**Appendix J**

Concession Space Requirements and Concession  
Program

**SUBJECT:** *Concession Space Requirements for LFMP*

**Figure 1**  
**Concession Space Requirements (SF per 1,000/Enplanements)**

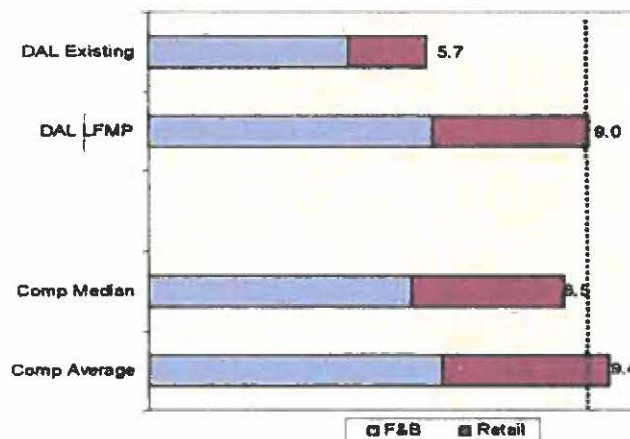
Unison's concession space requirements for the LFMP is 9.0 square feet per 1,000 annual projected enplanements, which is based on an analysis of facility, passenger, and concession characteristics for the new terminal. This number is in line with other medium hub airports. Our analysis of 23 comparatively sized airports indicates optimal concessions are sized between 8.5 to 9.4 square feet per 1,000 annual enplanements (Figure 1).

It is important to note that the comparable airports referenced in the memorandum include a limited number of airports (only seven), many of which are undersized and generate relatively low sales per enplanement. Our analysis includes a wide range of medium hub airports including new and older concessions programs, which is best for benchmarking purposes.
